Questions for DUNE following the LBNC Review of Vertical Drift on April 28, 2021

May 10, 2021

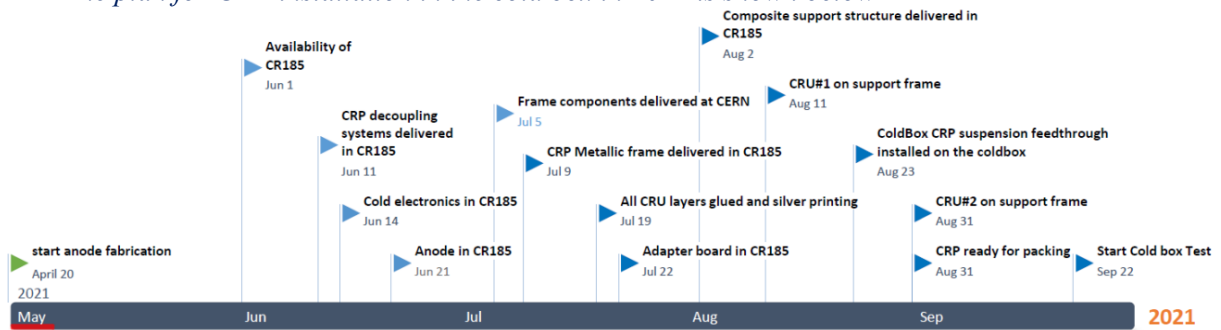
- b. What is the role of DUNE Technical Coordination in the current VTPC effort? (Again, responsibility is shared with other DUNE subprojects.)

VTPC effort for detectors components is based on the DUNE consortium system. The DUNE TC is in charge of all consortia and therefore he is well positioned in this process. The deputy TC has been mandated to overview the VTPC process and is very active in steering the various activities and keeping close contact with the consortia.

VTPC is strongly based on international partners, TCn is distributed across several institutes and laboratories. The engineering effort is very visible as is demonstrated by the enormous progress achieved in the last 6 months.

On top of this the LBNF I&I project is very active and works very closely with DUNE TCn. FNAL, BNL, IN2P3, INFN and CERN are very active in all of the R&D and demonstrator activities which are now in full swing. With VTPC the DUNE TCn has become more efficient and more proactive, helping in an important way the various consortia. The IPO is fully engaged in VTPC and is helping with reviews, ESH, QA and systems engineering.
